KX1 OWNER'S MANUAL ERRATA

Rev. D-1, October 19, 2009

3. **Page 53, Figure 24:** *If your kit was supplied with a 2SC2166 transistor instead of a 2SC5739*, replace the figure with the following drawing. The drawing is sized so you can cut it out and paste it over the existing drawing in your manual.

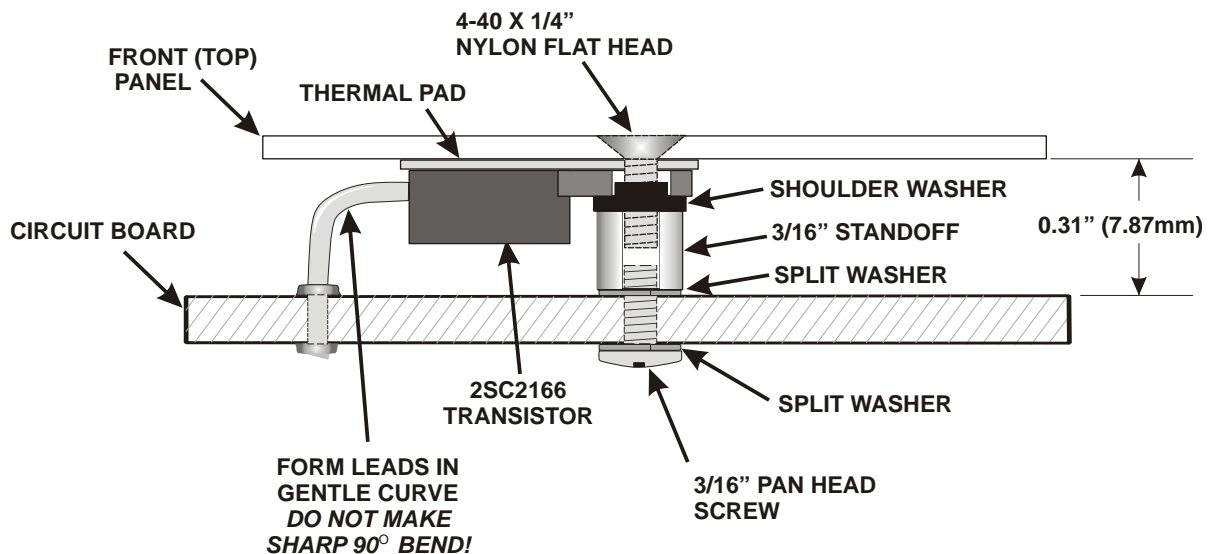
Locate the silk-screened outline for Q6 at the top edge of the circuit board. Install the 3/16" (4.76 mm) standoff on the circuit board using a 3/16" pan head screw and two split washers as shown in the figure. **The split washer under the standoff is important to reach the proper height so Q6 will come in contact with the cover.** Be sure the screw head or washer is not touching the windings on L3 on the bottom of the board. They may touch the toroid core in the space between the windings.
